MEETING OF THE MINTURN PLANNING COMMISSION Minturn, CO 81645 • (970) 827-5645

Wednesday, May 12, 2021

Re: 701 Boulder Street – Bilello New Residence Modification to Approved Plans

Re: 482 Eagle River Street – Hutton New Residence Modification to Approved Plans

UPPER LEVEL FLOOR PLAN

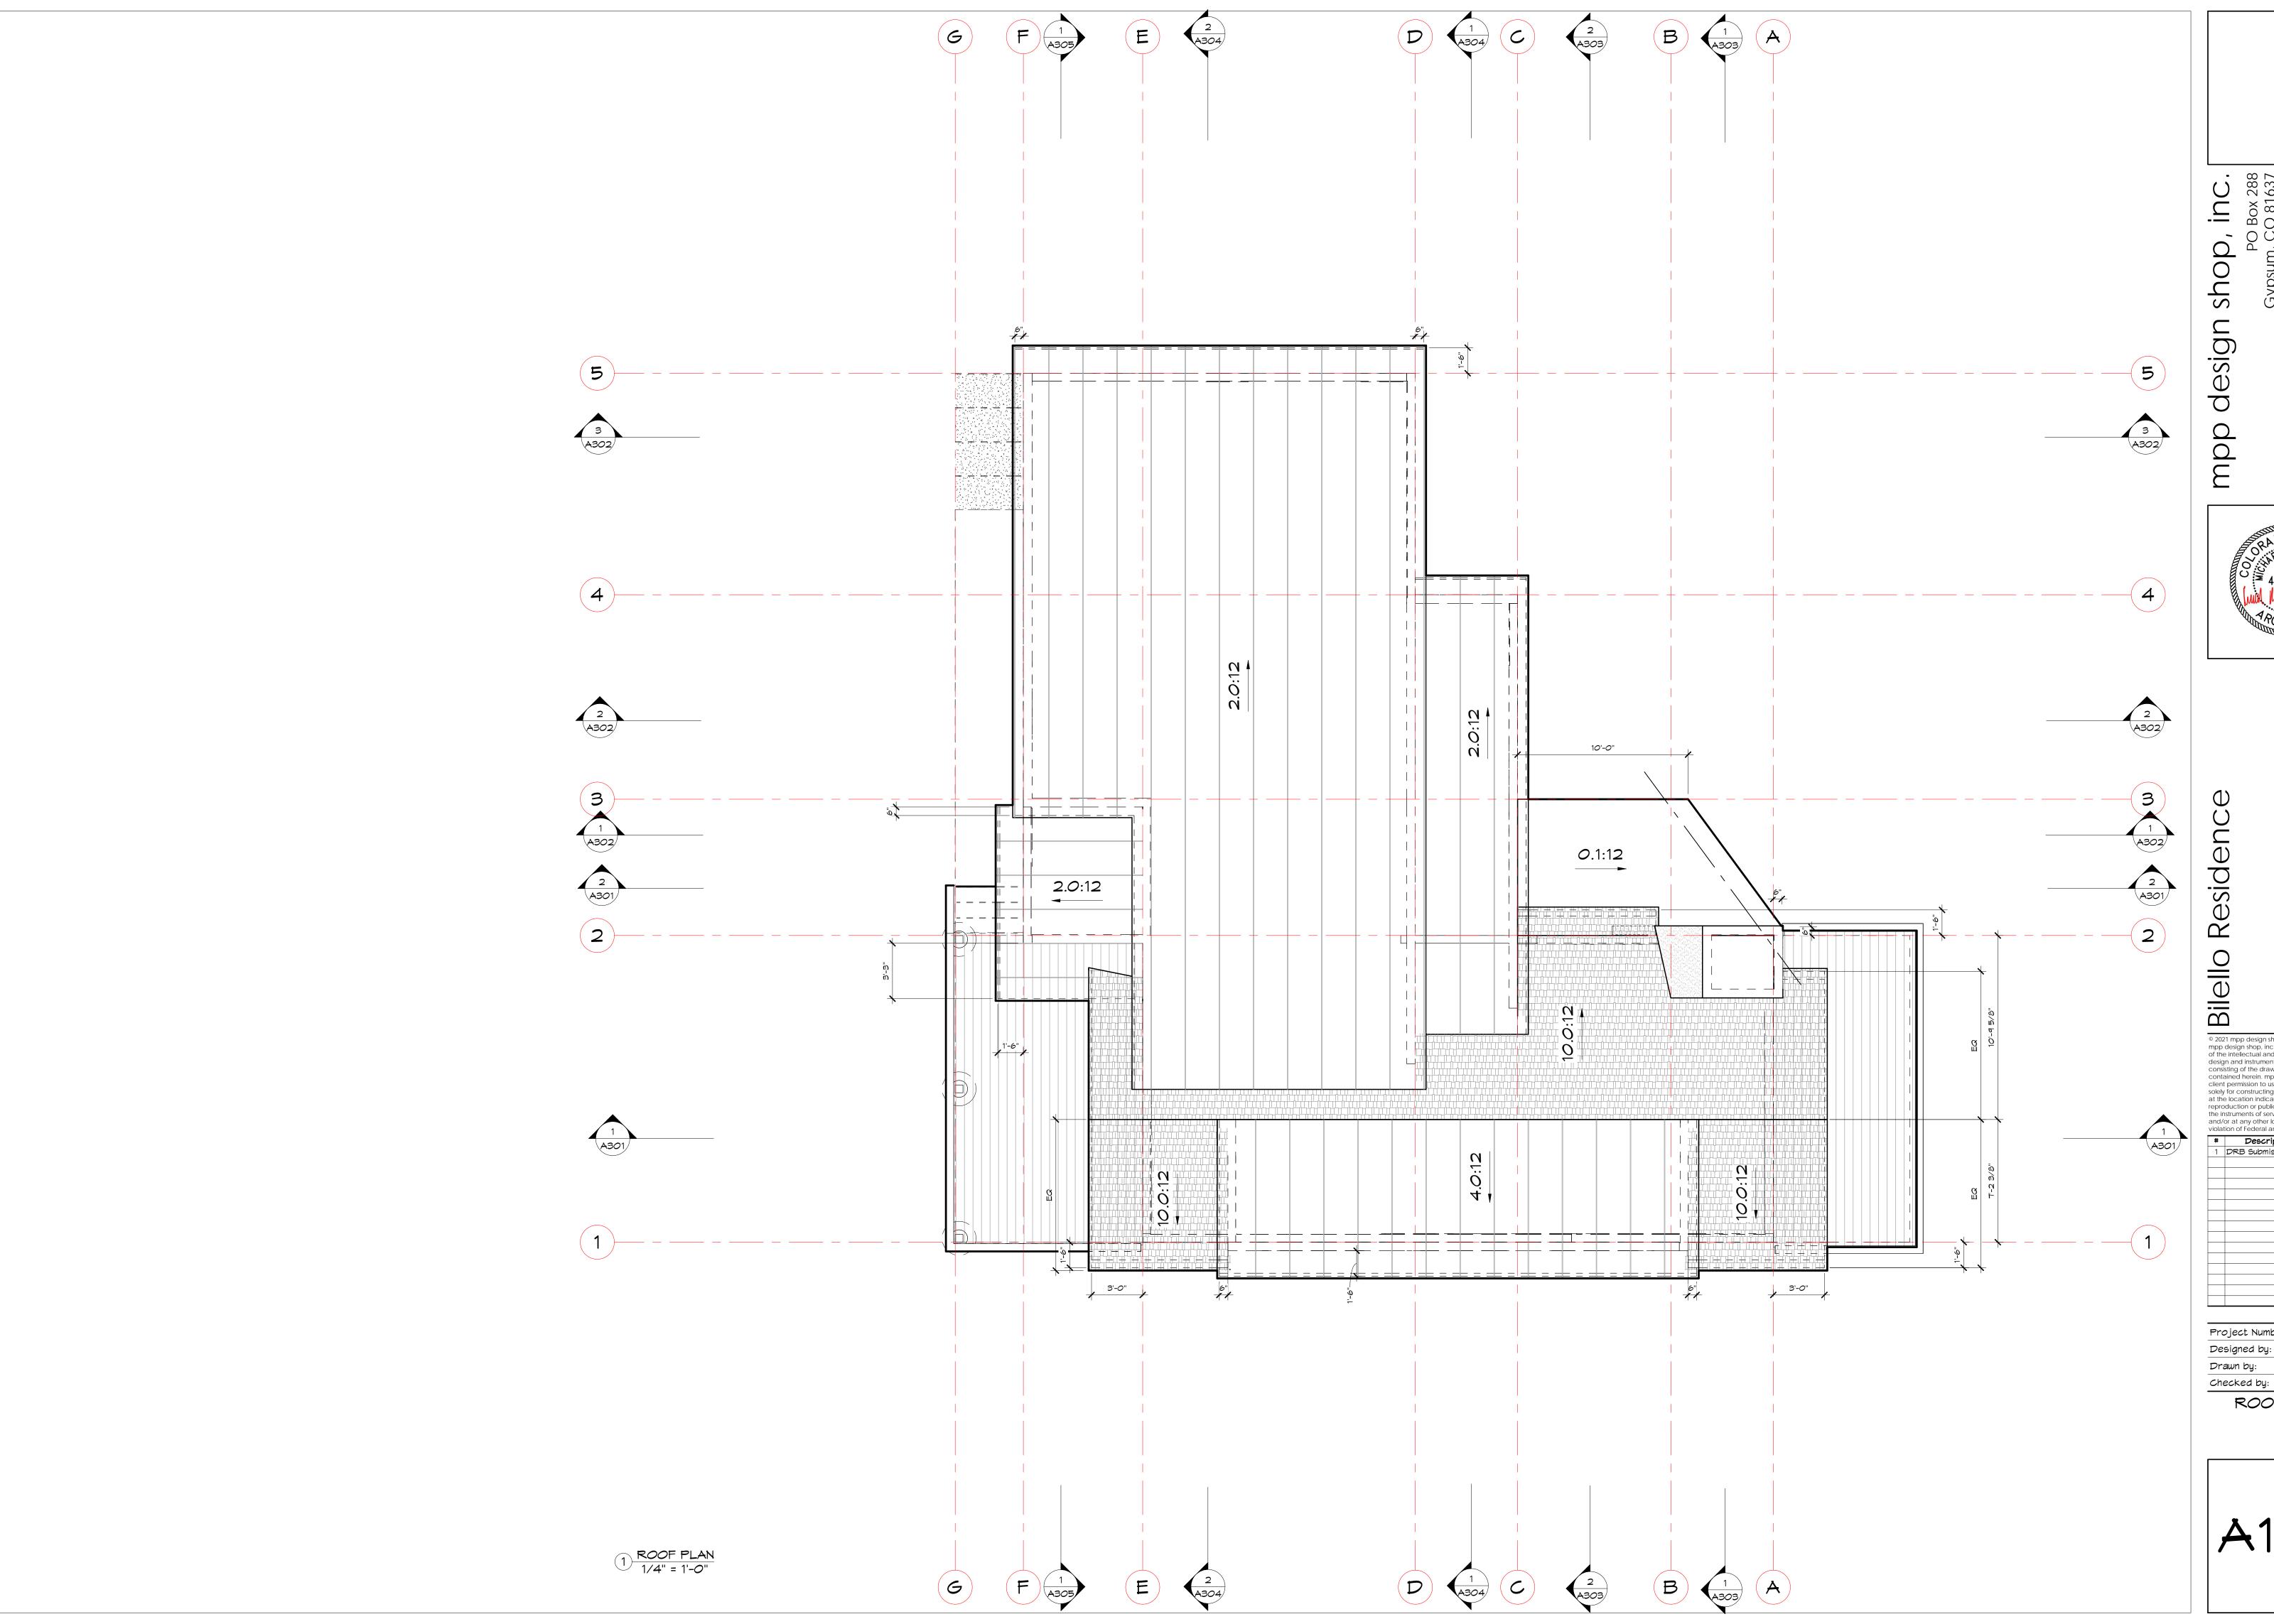
- At the front entry, the flat roof on the second level above the bedrooms and upper hall has been changed to a sloped roof. (Sheets A104, A201, A202)
 - The corner window was eliminated (Sheet A103)

трр Checked by: EAST & SOUTH

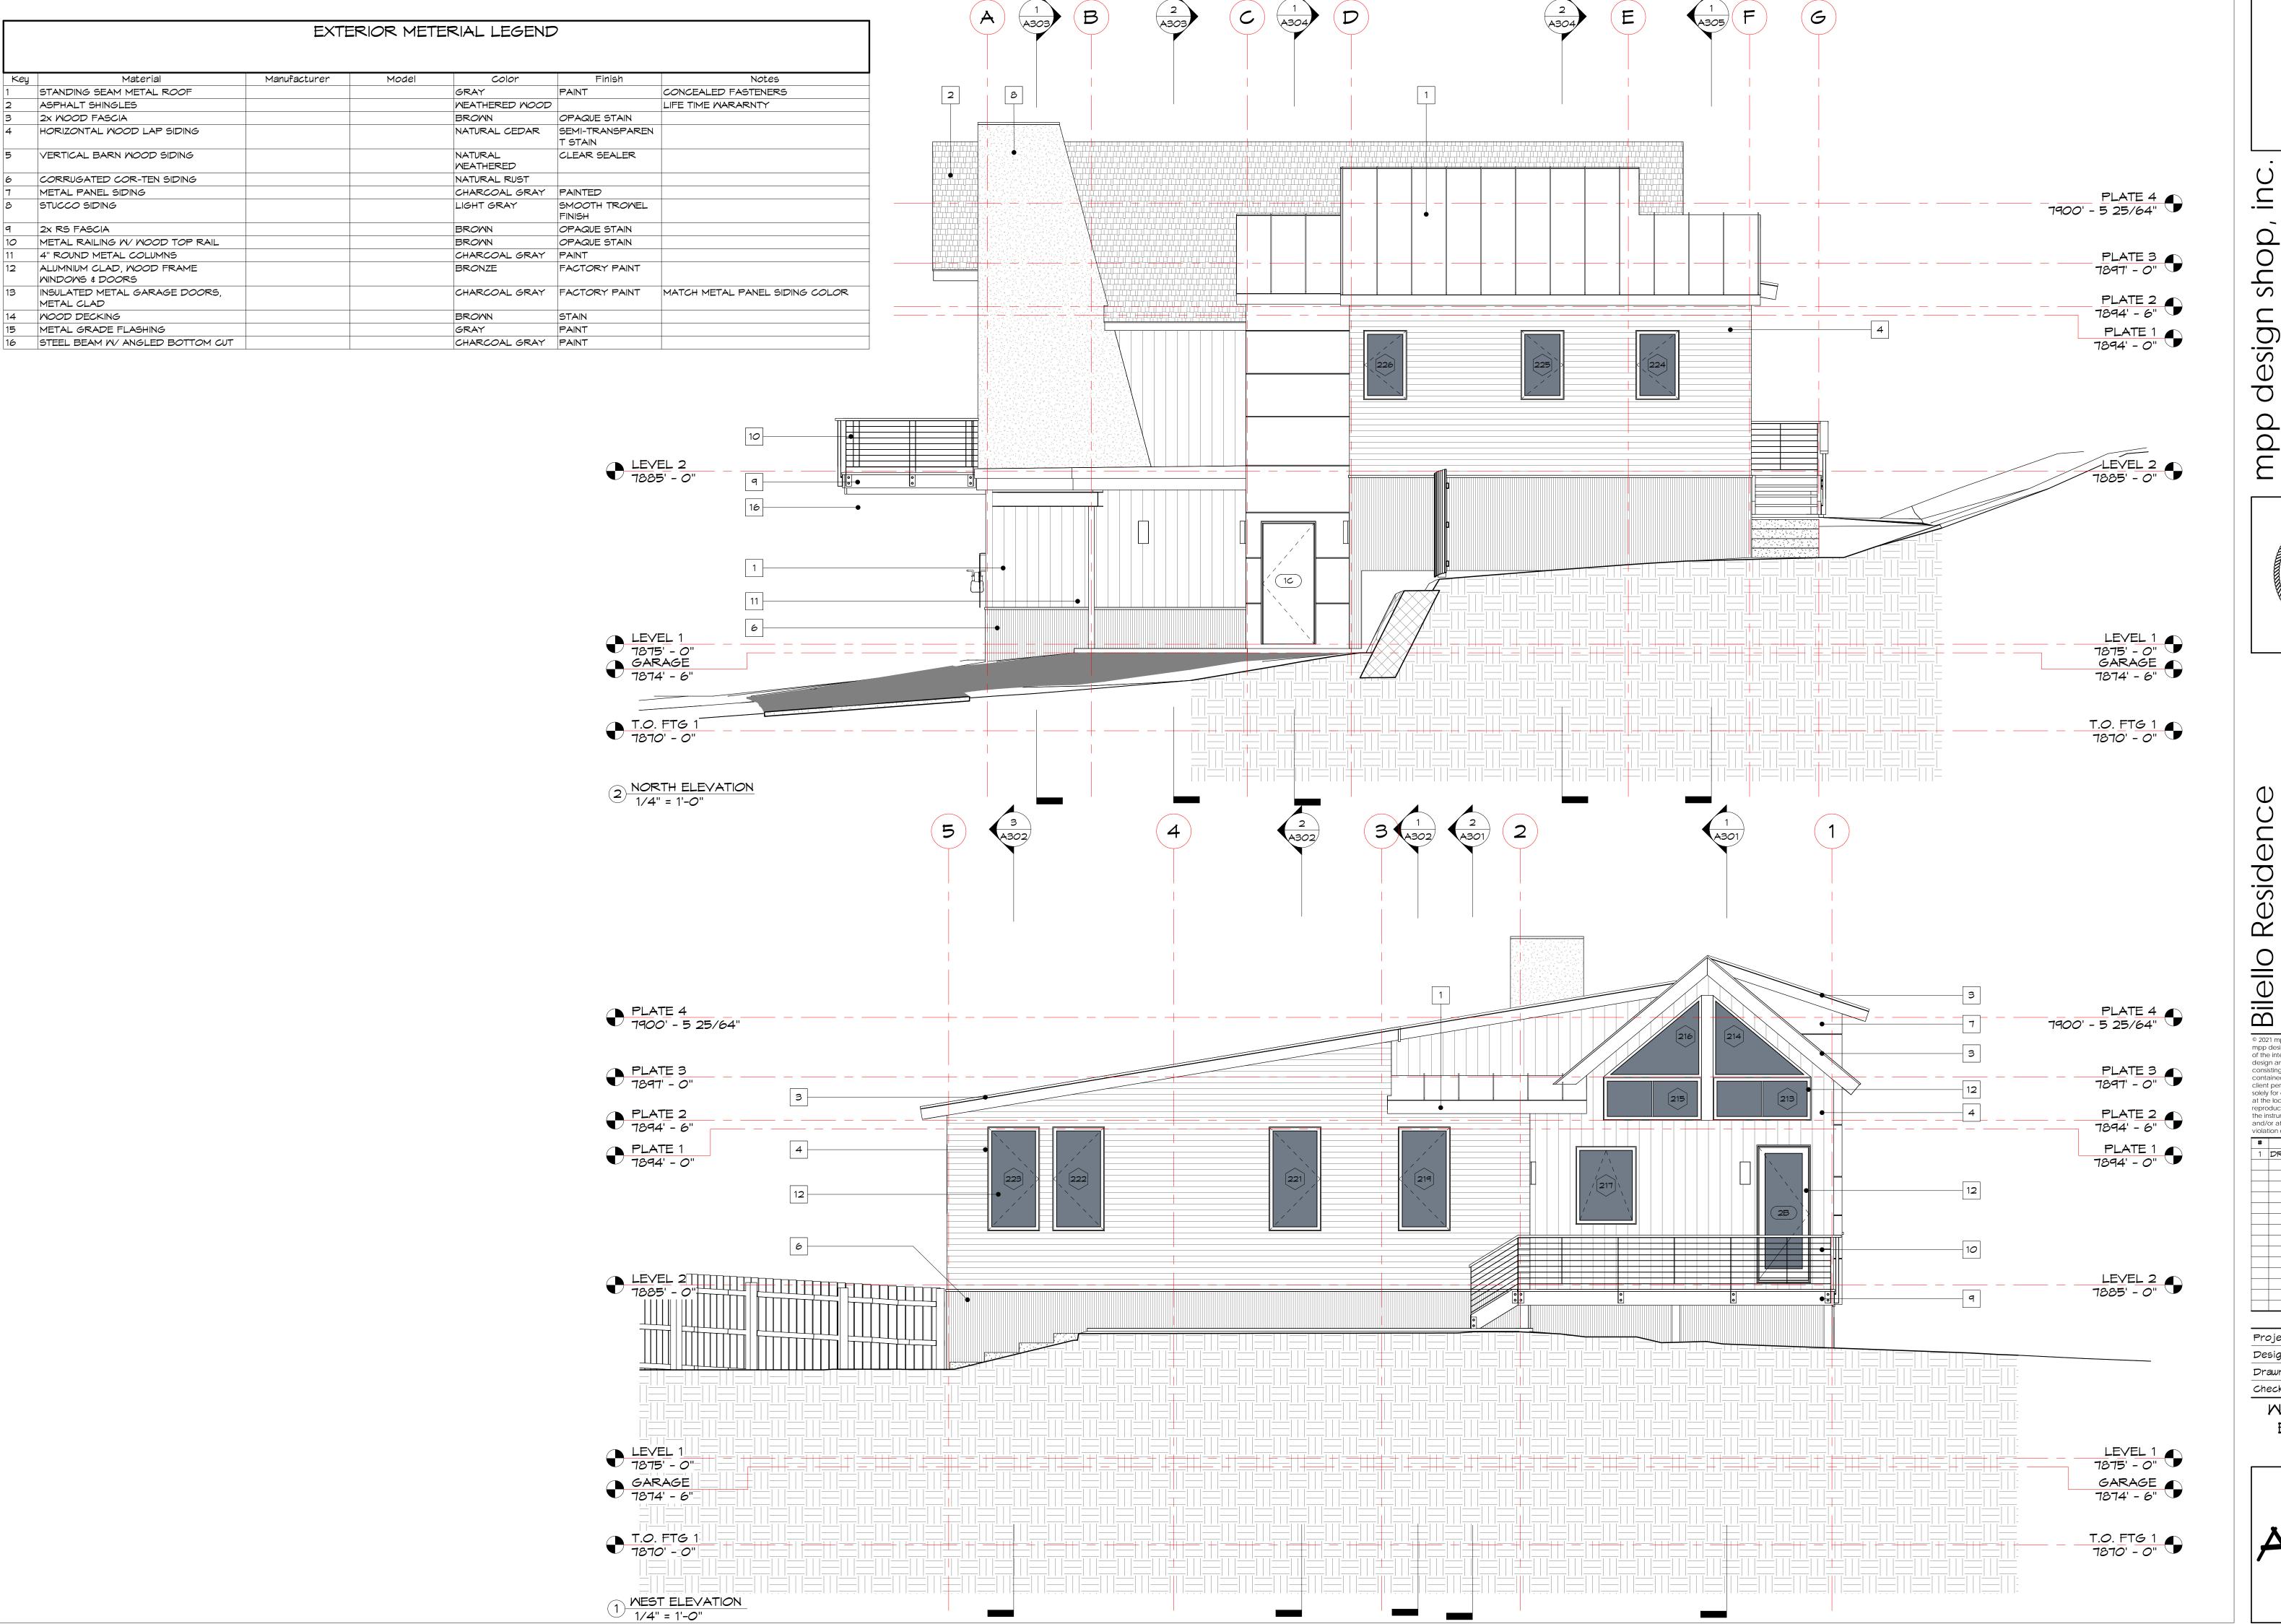
- Trapezoid windows were added that follow the sloped roof (Sheet A201)
- The sliding door on the east elevation at the great room on the upper level has been changed from 8'-0" tall to 10'-0" tall (Sheet A201)

- The trapezoid windows above have been modified to accommodate the new door height (Sheet A201)
- On the south elevation at the great room on the upper level, the dormer has been dropped to the floor level (Sheet A201)

- o I had originally design the dormer bay to be 3'-6" above the floor, but it was too complicated and expensive to construct in this manner and required a change in the design
